Status: Y N U**Seismic Walkdown Checklist (SWC)**Equipment ID No. 1-1805-53-015 Equip. Class¹² ZEquipment Description 480V Switchgear 1AD15Location: Bldg. Aux/41 Floor El. 119'-3" Room, Area RD105

Seismic Walkdown Checklist (SWC)

Equipment Description 480V Switchgear IAB15

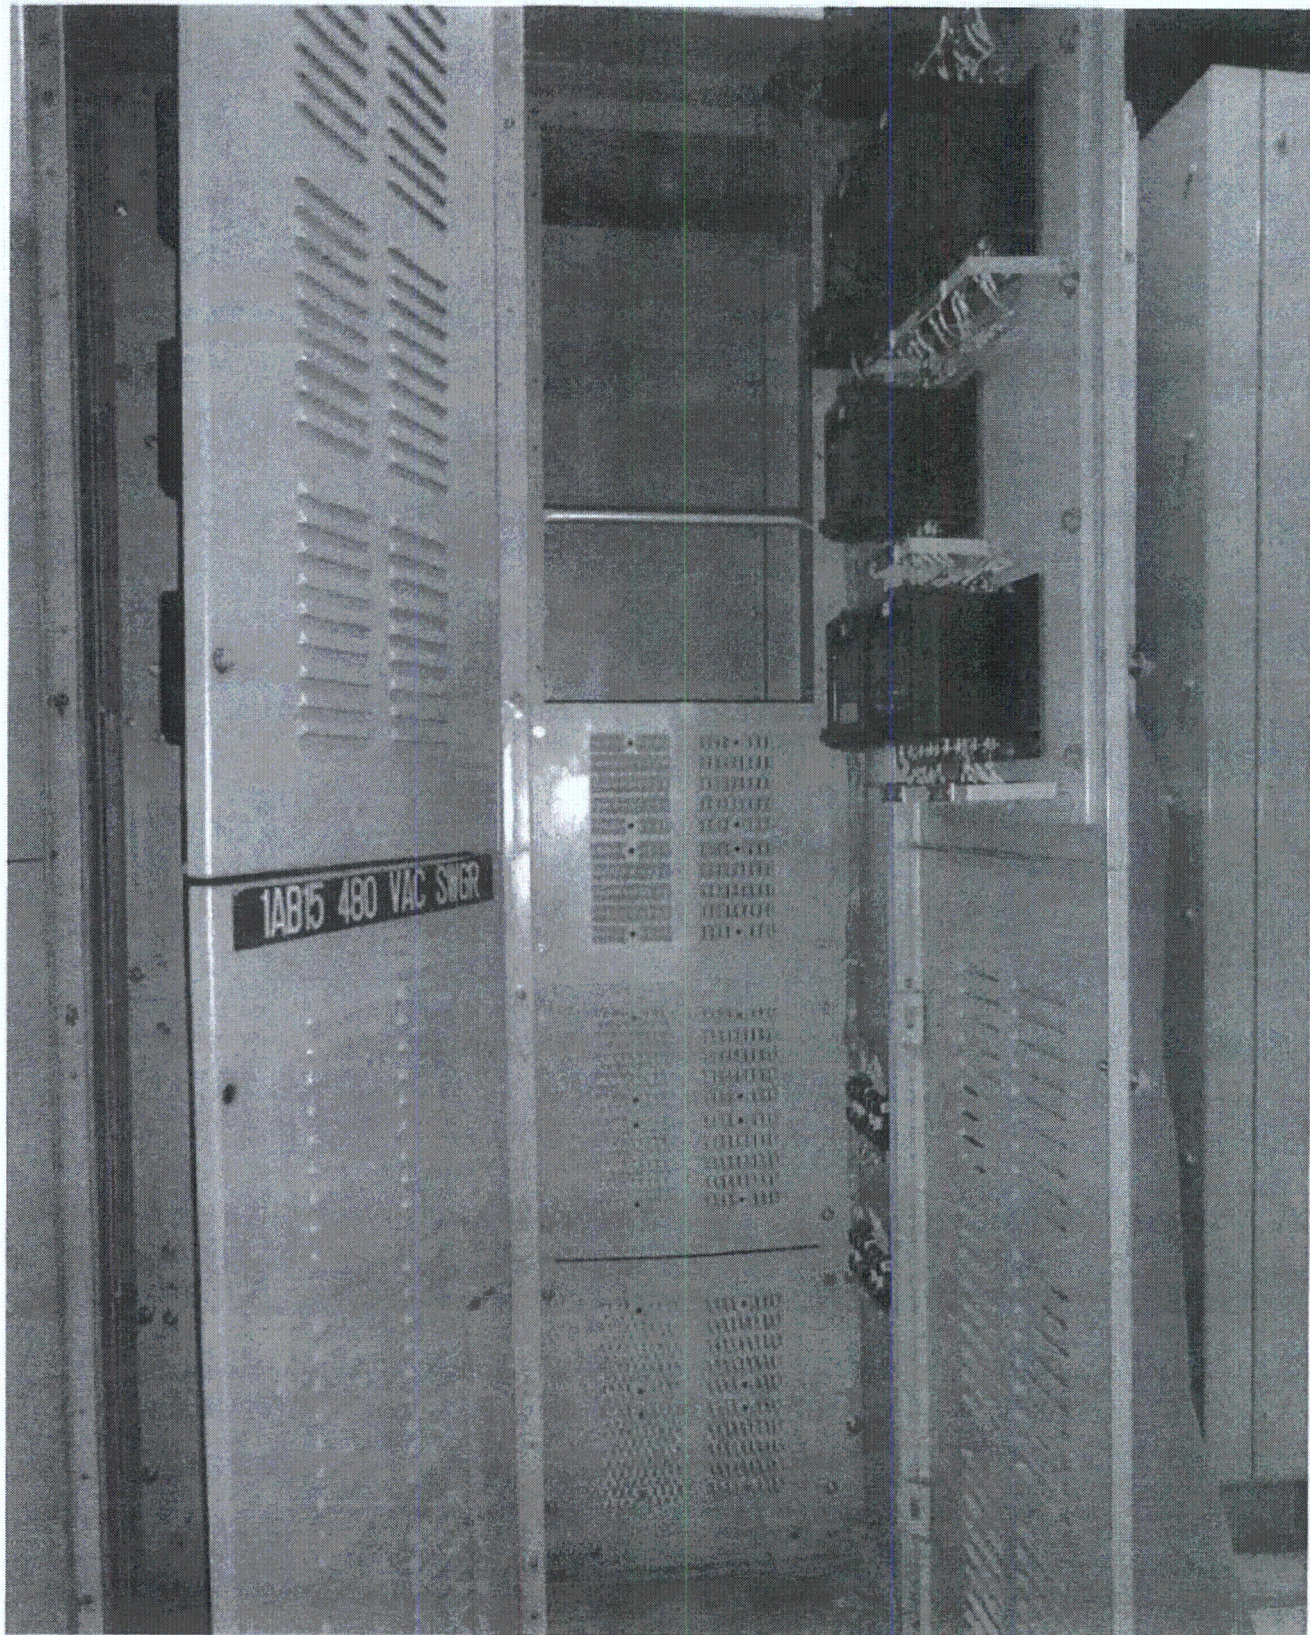
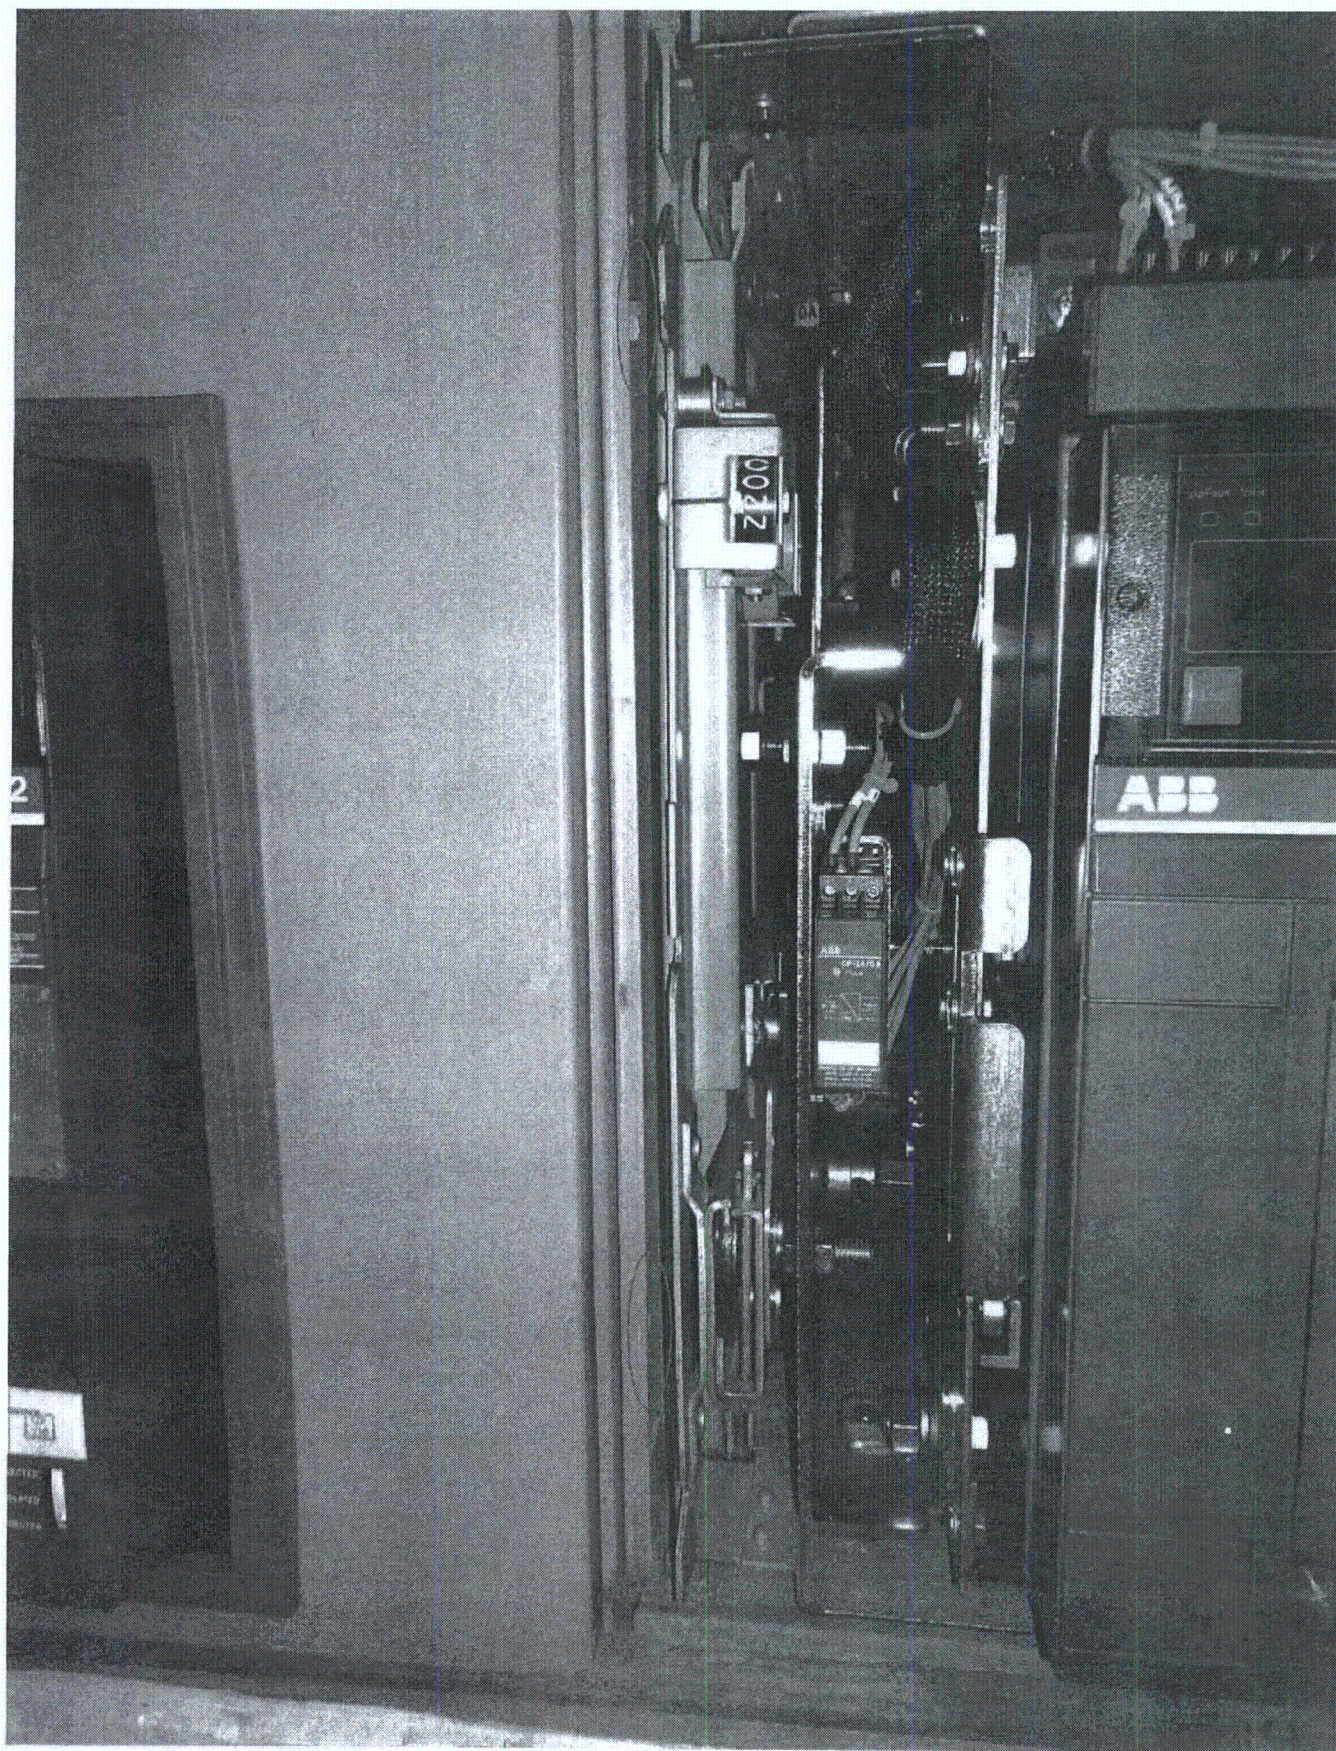
11. Have you looked for and found no other seismic conditions that could adversely affect the safety functions of the equipment? Y N U
A visual inspection of the internal components of this cabinet was performed to check for seismic adequacy to include any evidence of internal components not adequately secured, checked for fasteners connecting adjacent cabinets were in place, and evidence of other adverse seismic conditions. An interconnecting fastener was found to be missing. See "Comments" for further details.

Found one (1) interconnecting fastener missing between bays IAB1510 and IAB1506 on the lower left side of IAB1510. It was judged by this seismic walkdown team that this condition must be evaluated for seismic adequacy of this cabinet. Reference condition report 525340 generated for this case.

Equipment Description 480V SWITCHGEAR 1B807

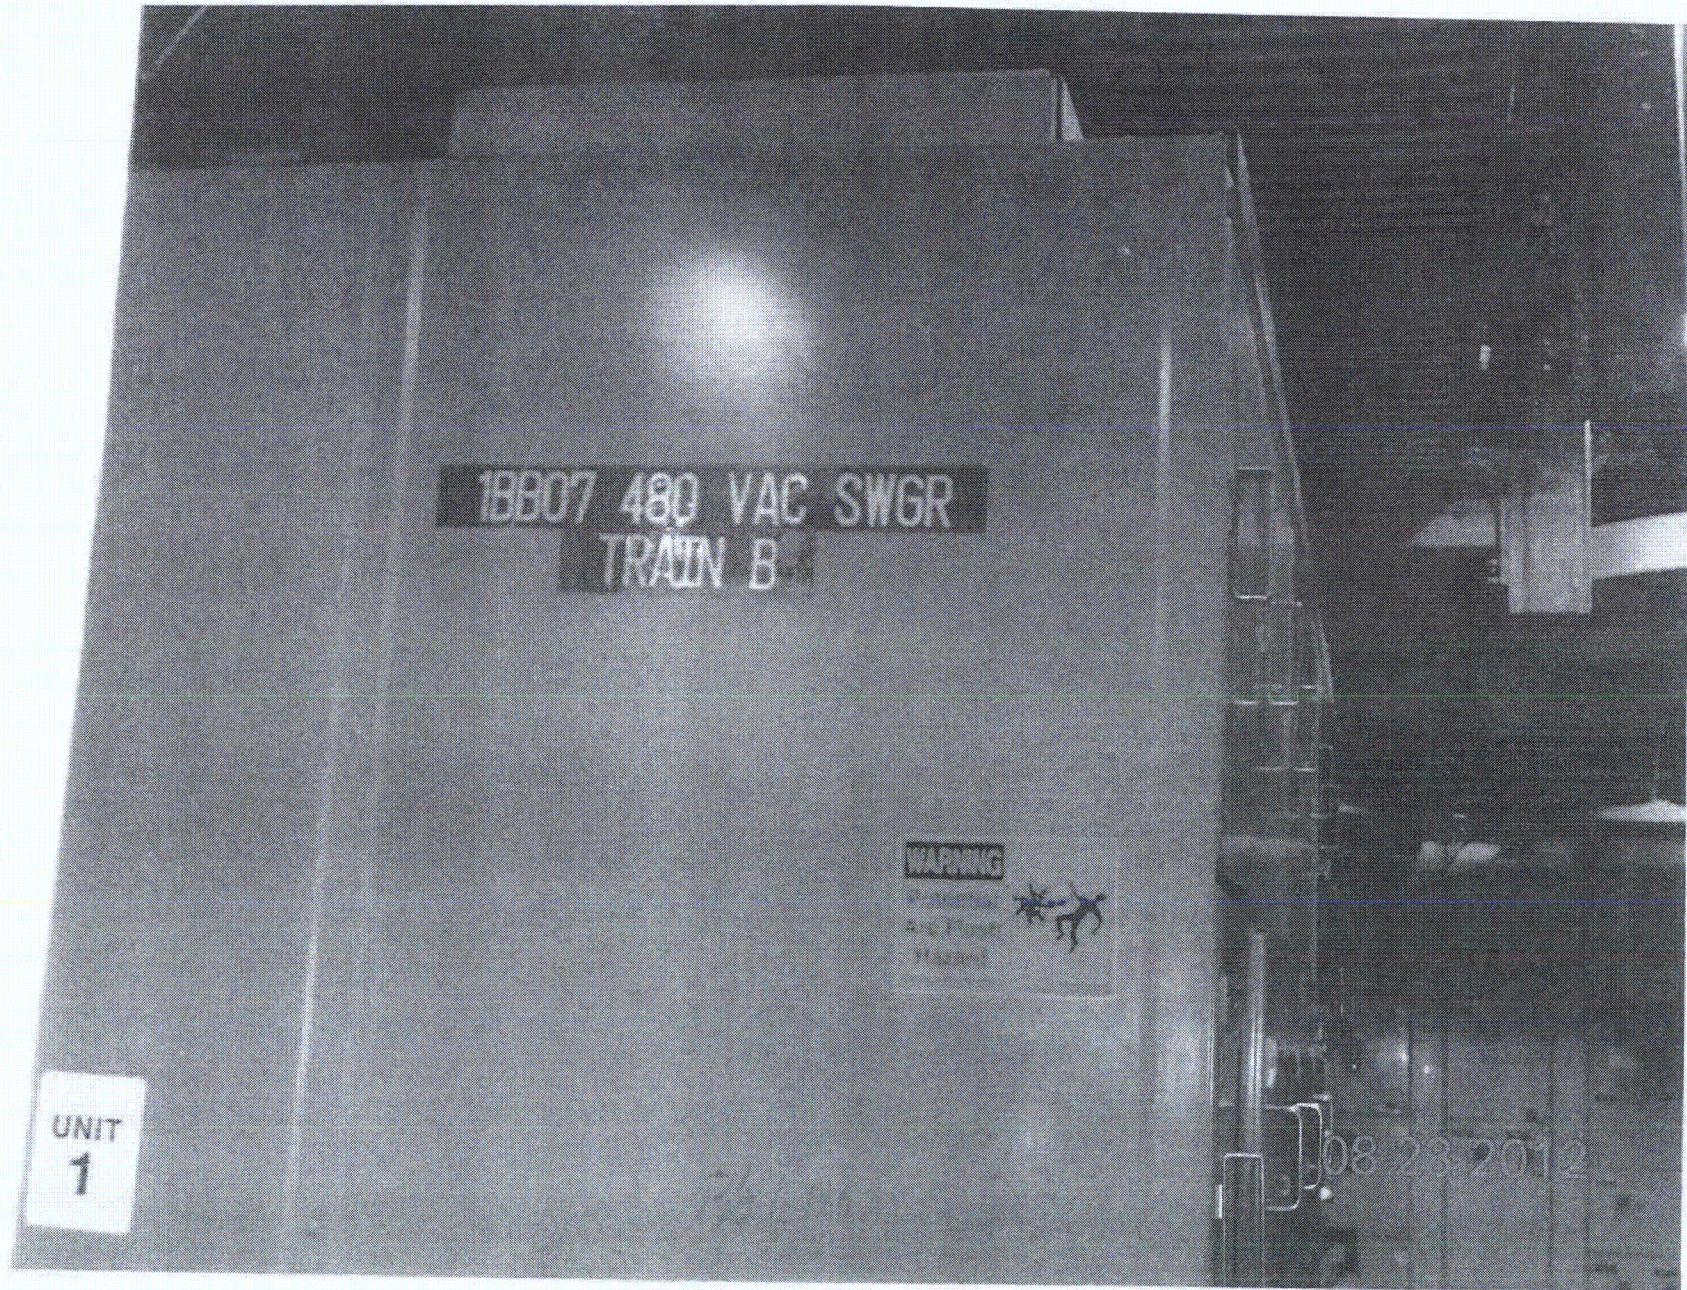
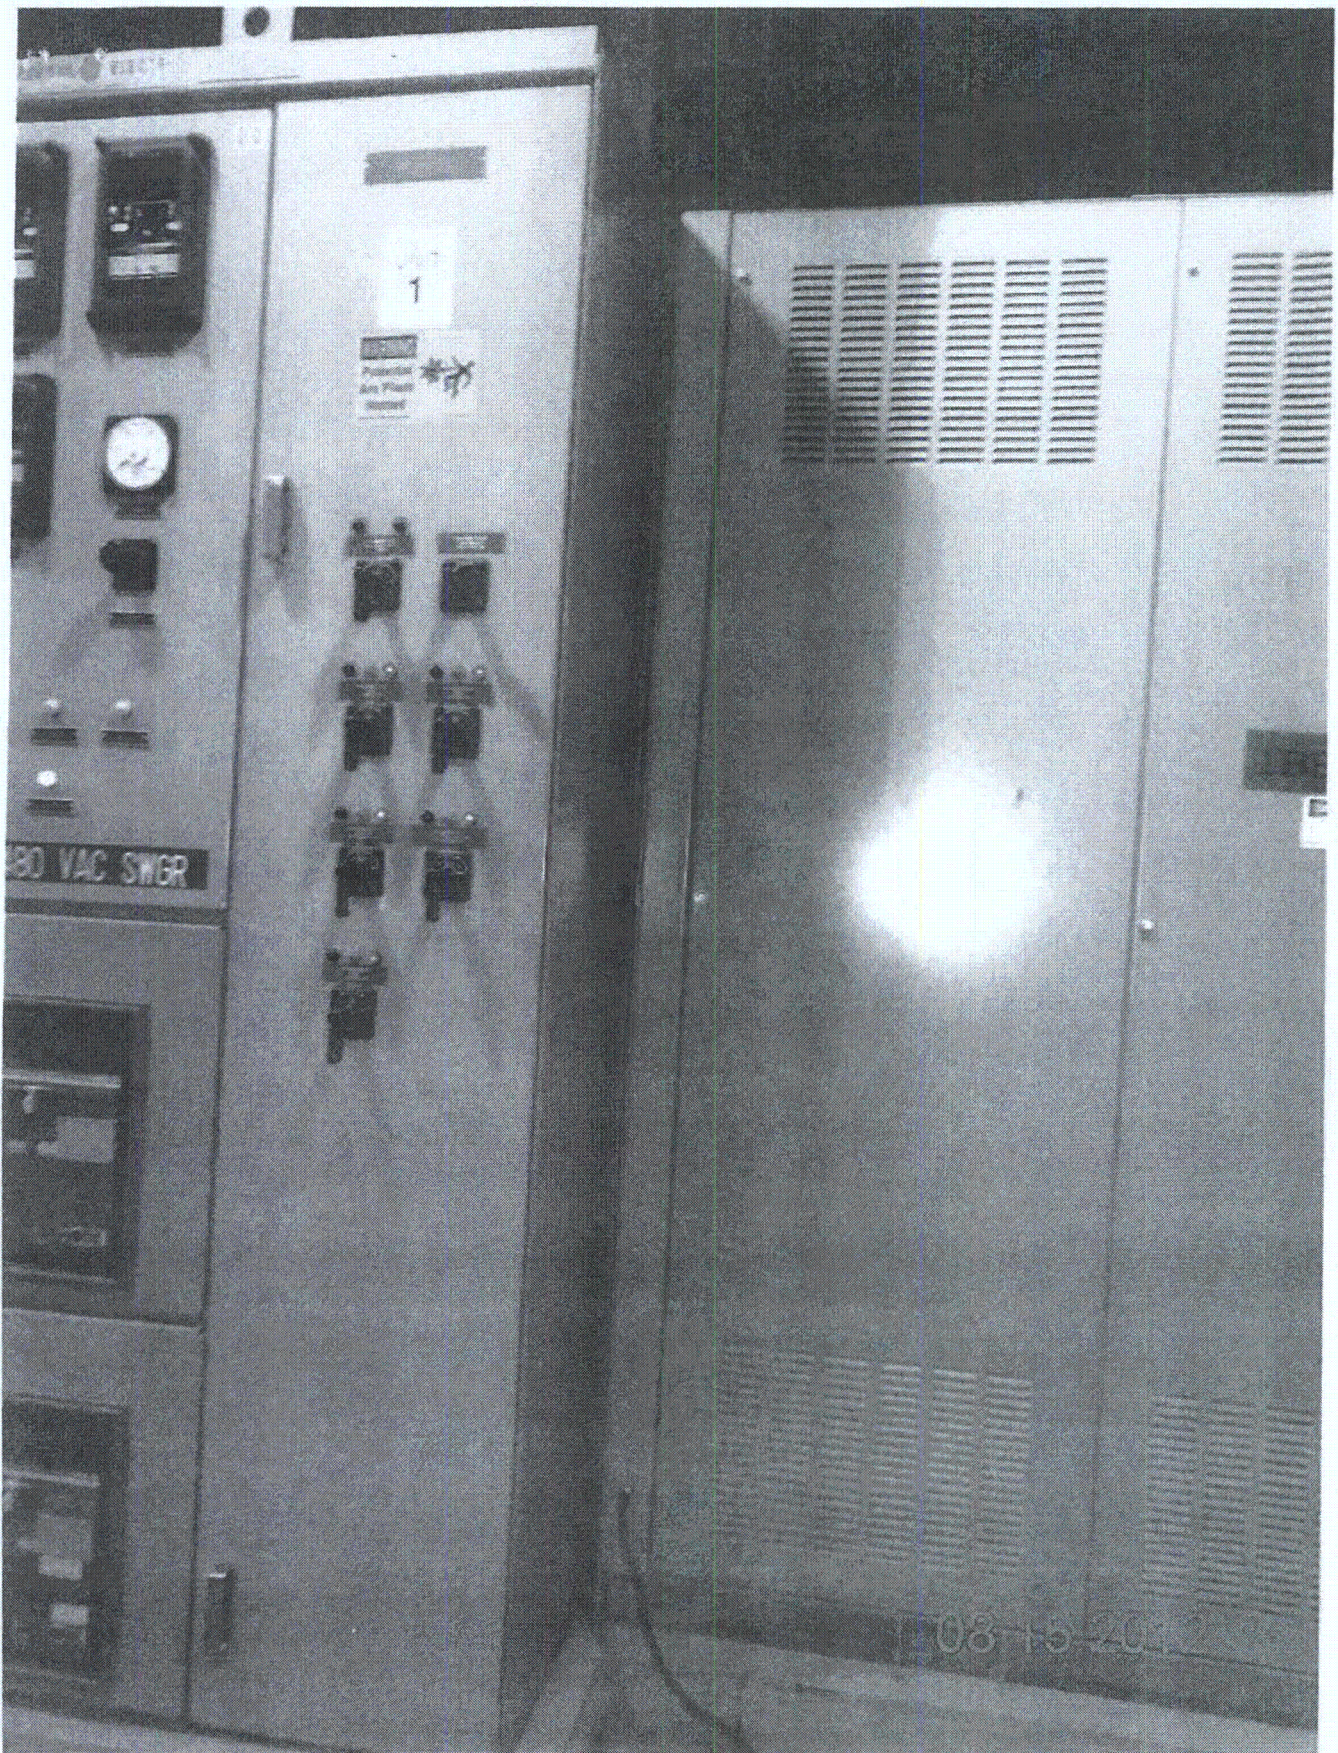
VENTILATION DUCT, SMALL CONDUIT AND ELECT GROUNDING BETWEEN 1B807 480VAC SWITCHGEAR AND 1B807X TRANSFORMER CAN BE SEEN AT 2" GAP. HOWEVER, THESE CONNECTIONS ARE NOT FIXED AT SWITCHGEAR SIDE, NO CONCERN FOR SPATIAL INTERACTION.
